UNITED STATES PATENT AND TRADEMARK OFFICE

APPLICATION NO.	FILING DATE	FIRST NAMED INVENTOR	ATTORNEY DOCKET NO.	CONFIRMATION NO.
10/026,961	12/27/2001	Young Hun Ha	8733.524.00	7359
30827	7590	03/28/2005		
MCKENNA LONG & ALDRIDGE LLP 1900 K STREET, NW WASHINGTON, DC 20006			EXAMINER LANDAU, MATTHEW C	
			ART UNIT	PAPER NUMBER
			2815

Office Action Summary

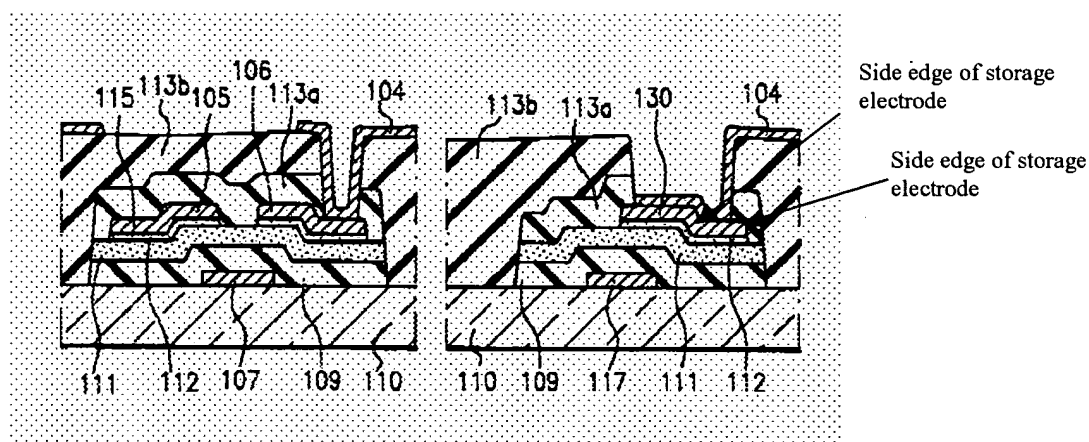
comprising: a storage electrode 130 having a first region (left side as shown in Figure 5I) overlapping the gate line to form a storage capacitor, and a second region (right side as shown in Figure 5I) offset and parallel to the gate line; and the pixel electrode covering an upper surface and side edges of the storage electrode, wherein the storage electrode is directly connected to the pixel electrode at the second region of the storage electrode. A marked-up version of Figure 5I is provided below for clarification.

In response to Applicant’s arguments regarding Han that “the first passivation layer 113a and second passivation layer 113b cover the upper and side surfaces of the storage electrode”, as

stated in the above rejection, the pixel electrode 104 covers an upper surface and side surfaces of the storage electrode 130 (see also the figure provided above that shows the “side surfaces” covered by the pixel electrode, wherein the slanted surface is considered a “side surface”). It is respectfully pointed out that the term “covering” does not necessarily imply contact. Therefore, as shown in Figure 5F, the right side of the storage electrode is covered by the pixel electrode.
